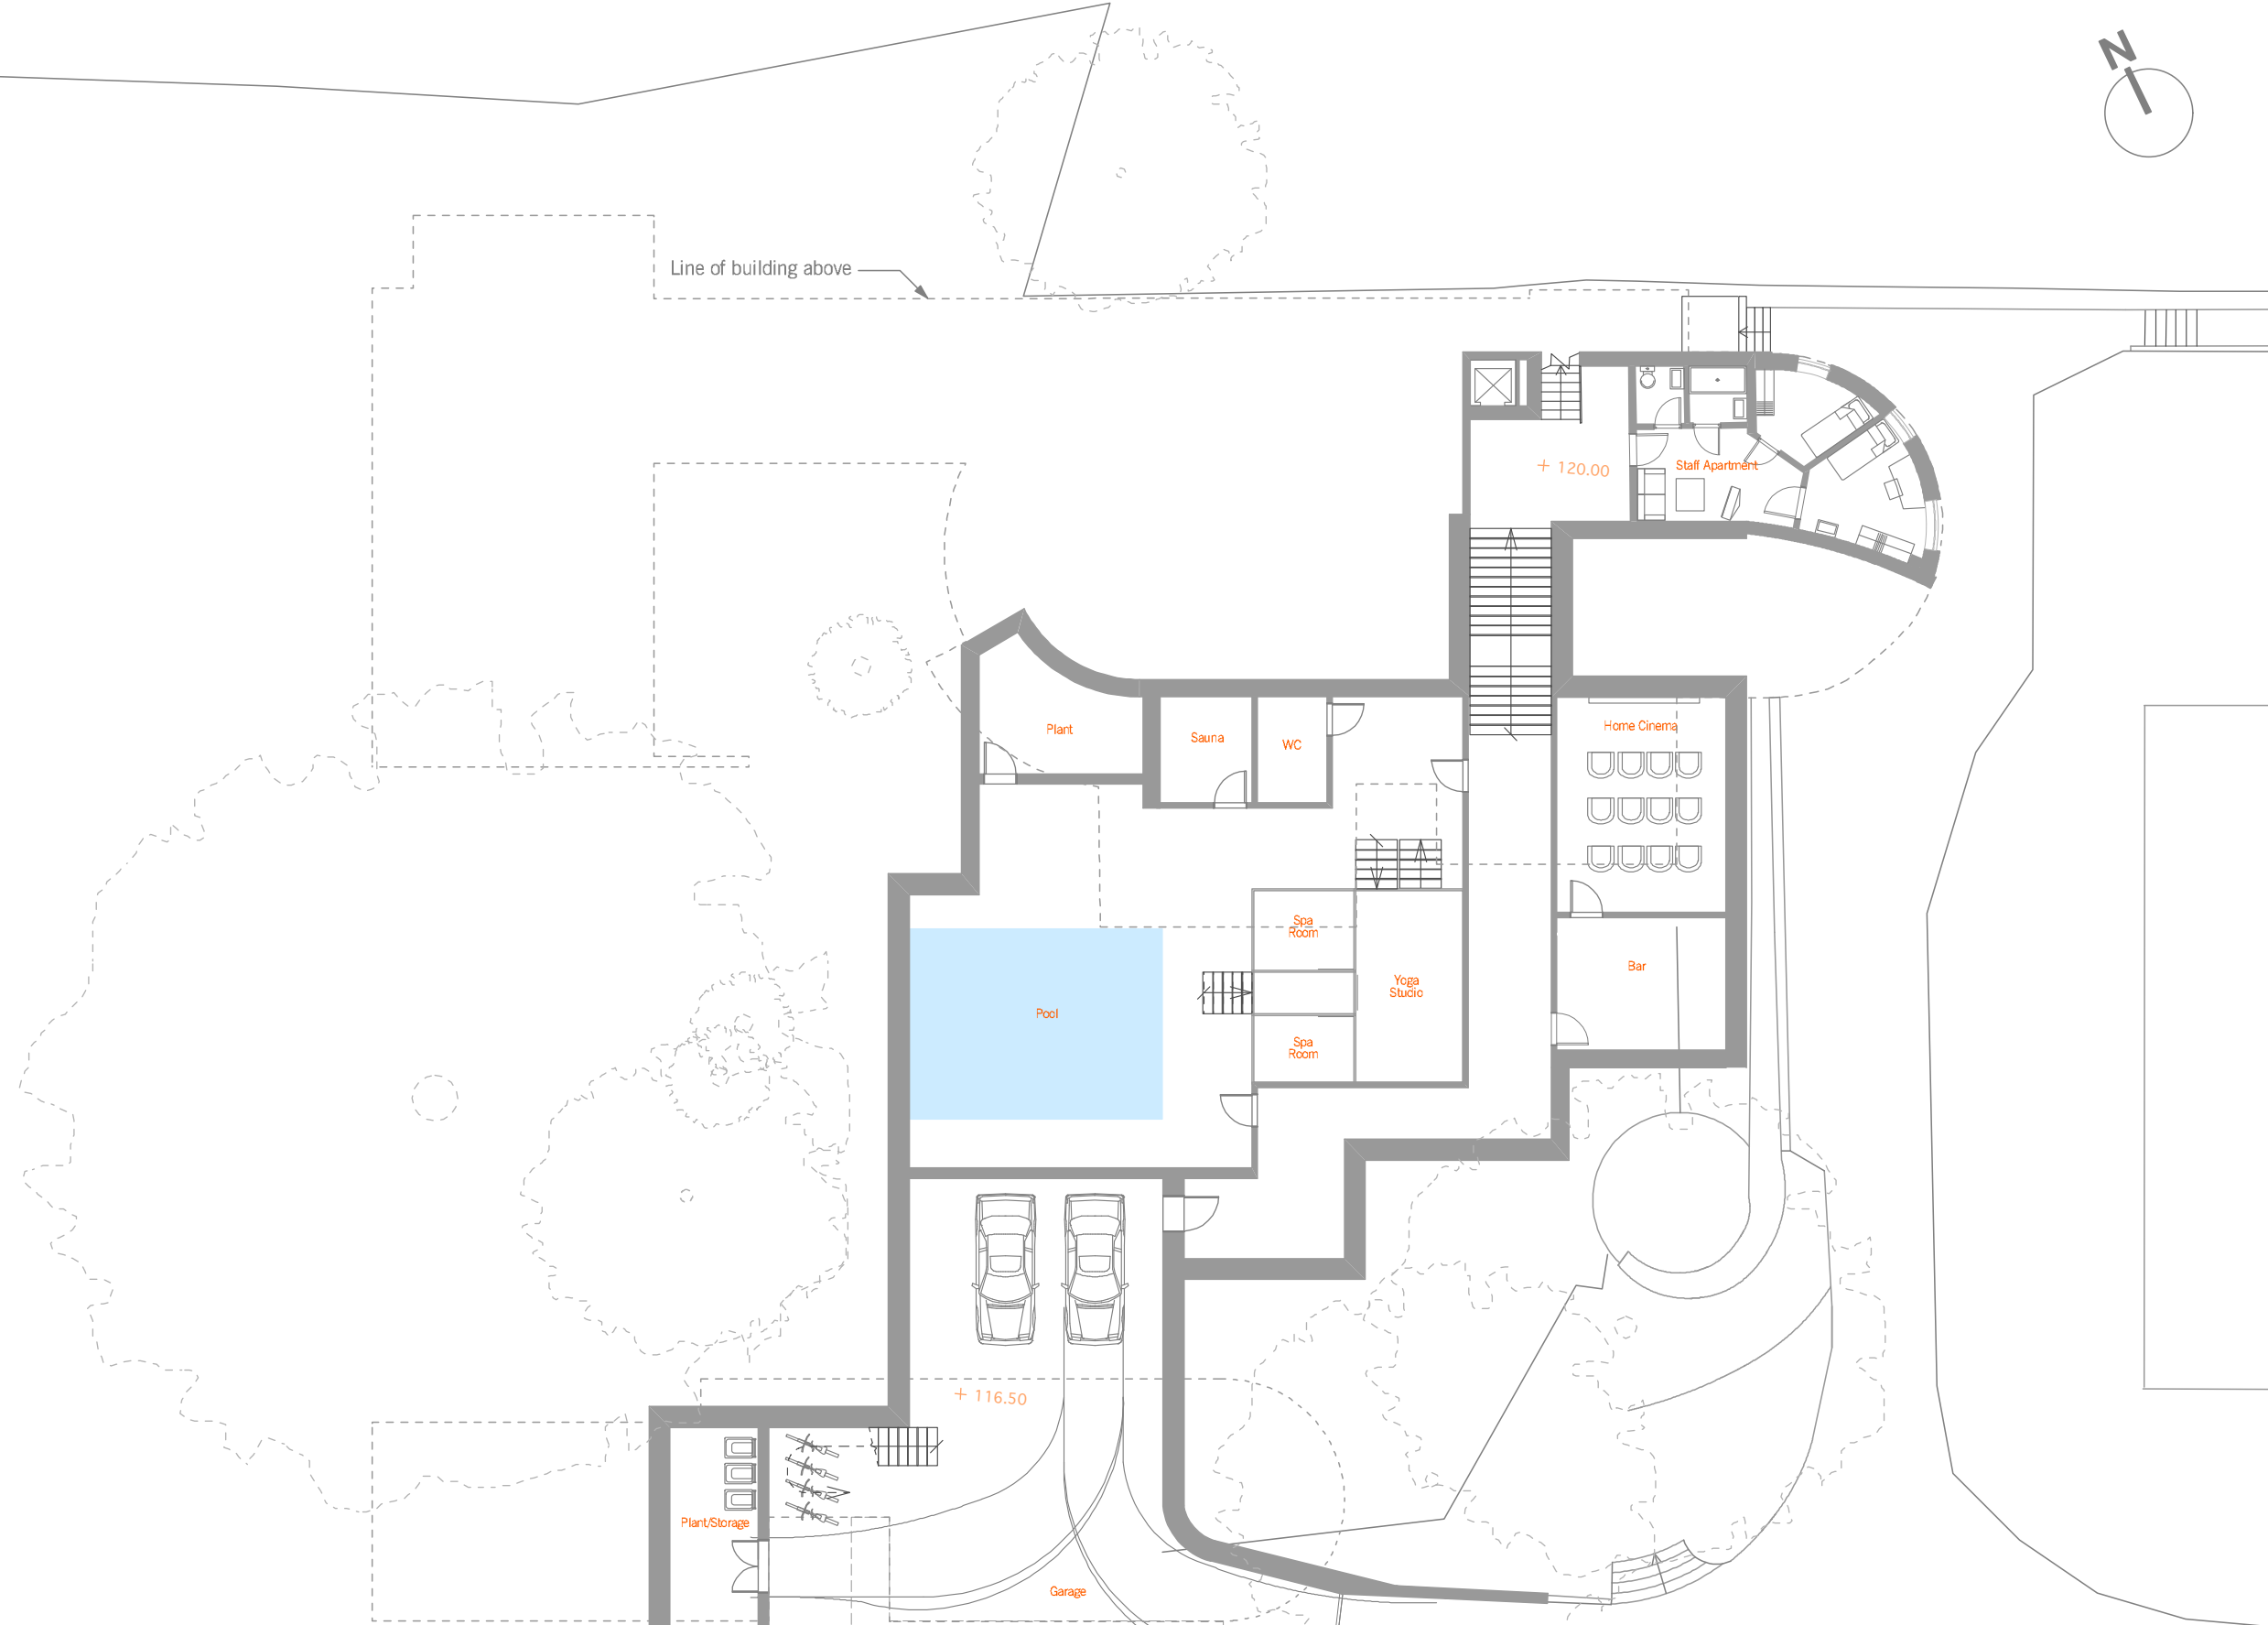
Rev A - 091009
 Outline of proposed extension revised.

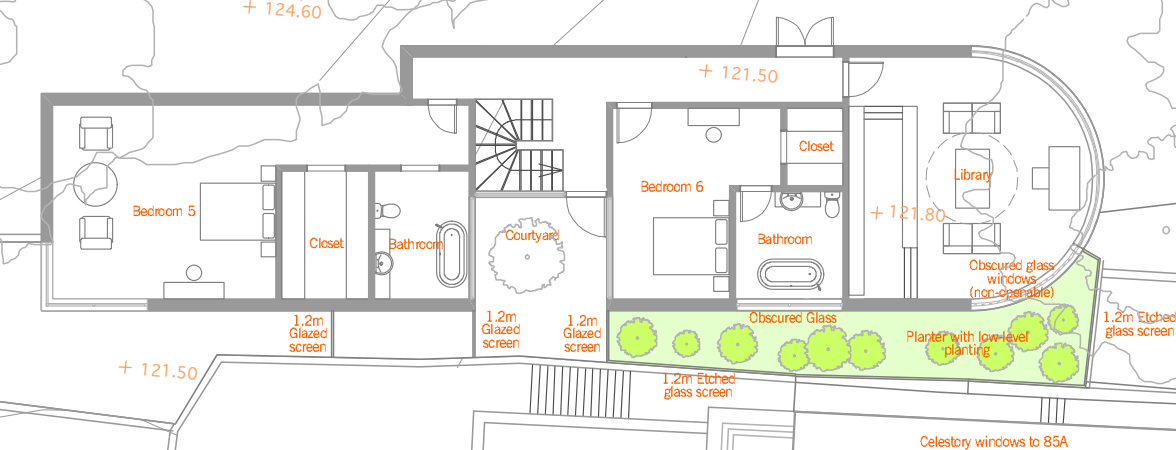
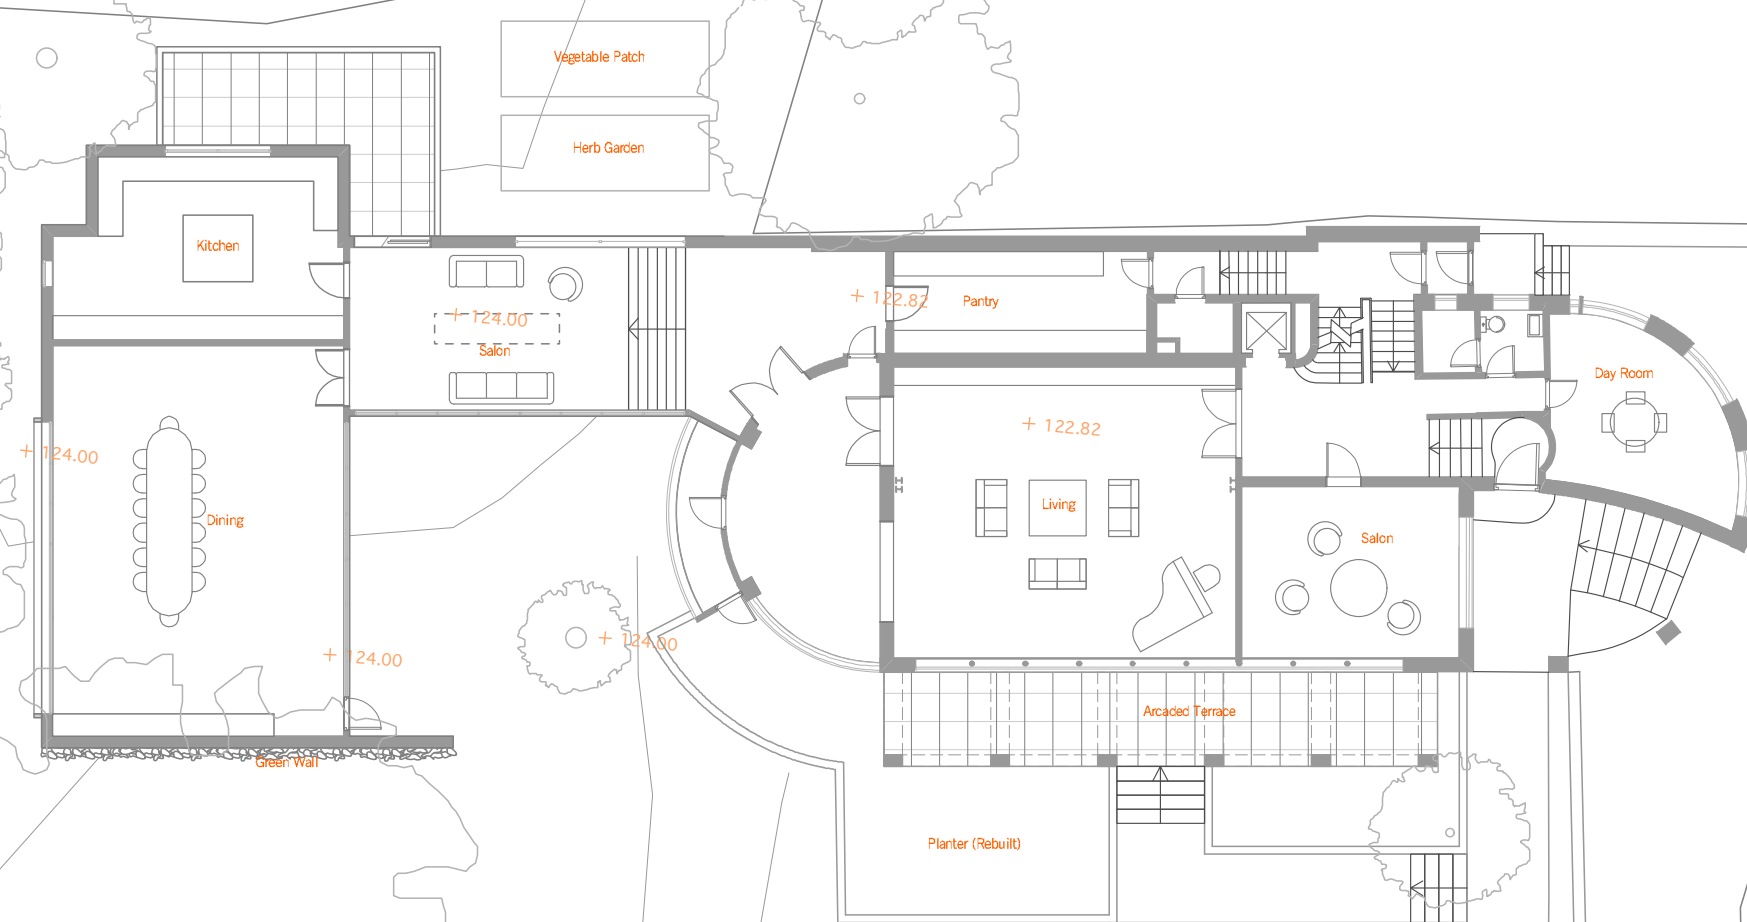
Rev A - 091009
Basement reduced south to protect root ball of poplar T6.
Outline of proposed extension above revised.

Rev A - 091009

Basement reduced south to protect root ball of poplar T6.

Light well next to sauna omitted and replaced by plant.

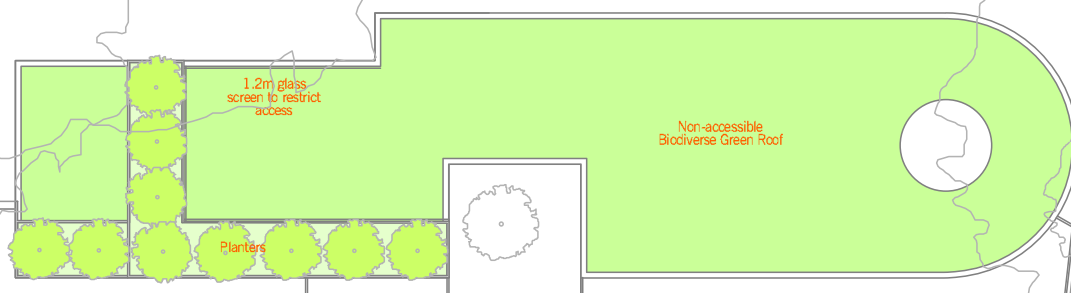
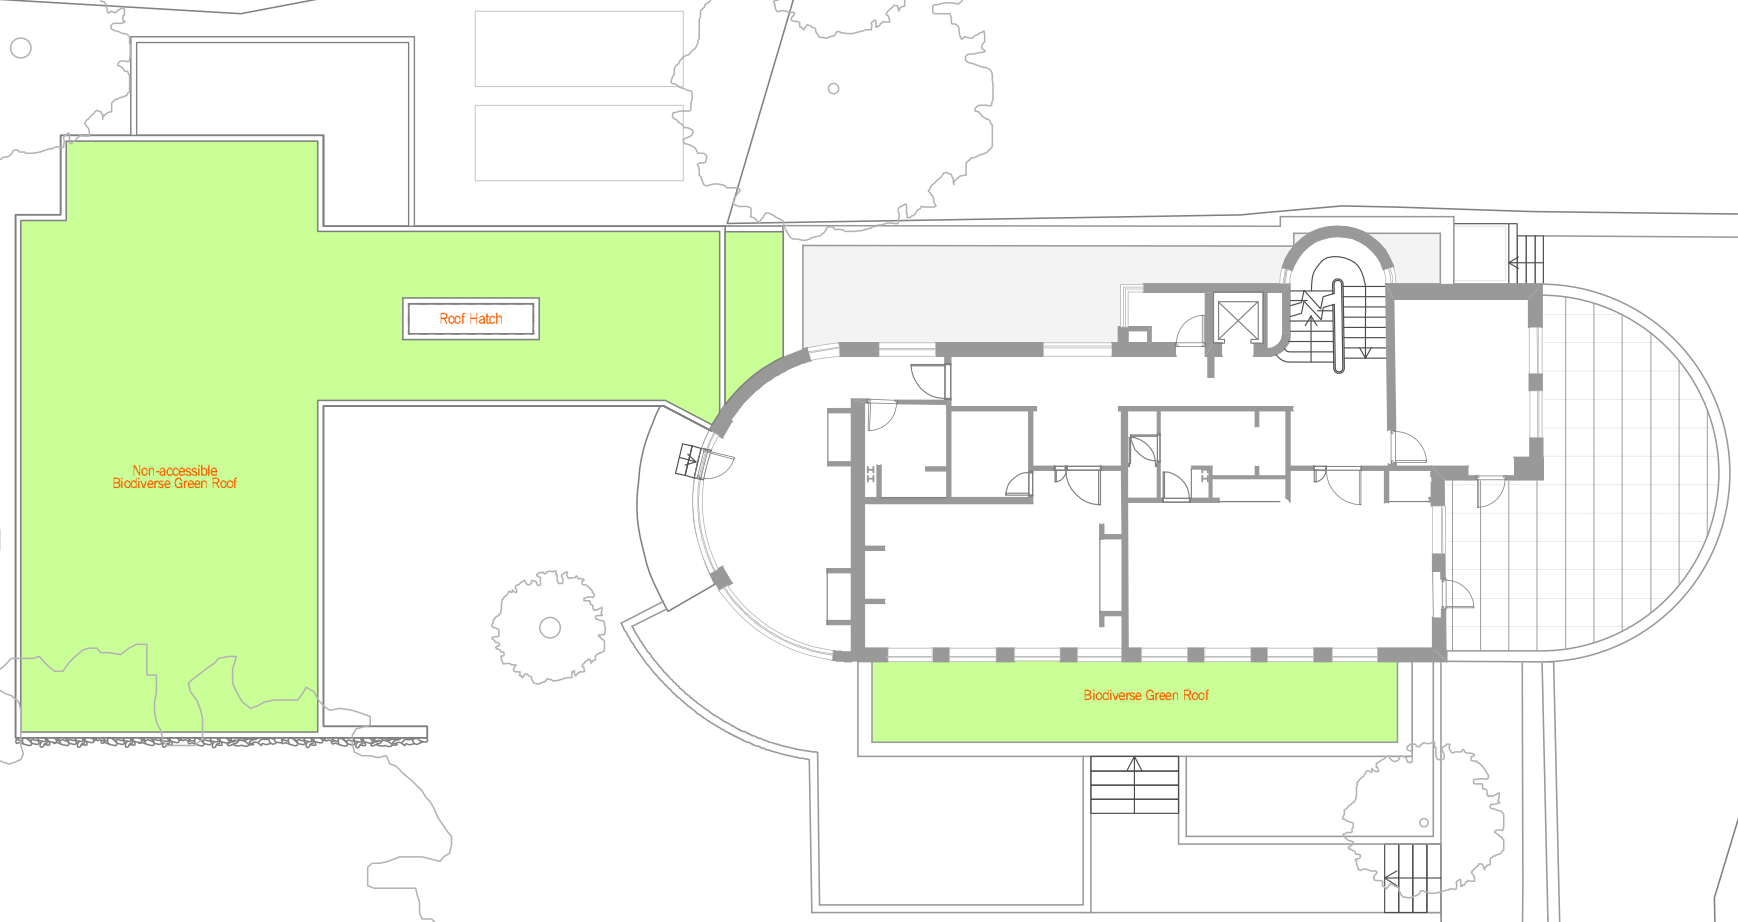
Outline of proposed building above revised.

Rev B - 091009

Dining room and kitchen moved west to protect root ball of poplar T6. Dining room reduced north by 500 mm. Hall widened.

Glass link removed.

South extension cut back to protect root ball of oak T11.

Rev A

Non-accessible low level planter added to south of annex.

1.2m glazed screens added to prevent access and overlooking to no 85A.

1/3 of library window specified obscured glass and non-openable.

Picture window added to west elevation of rear extension.
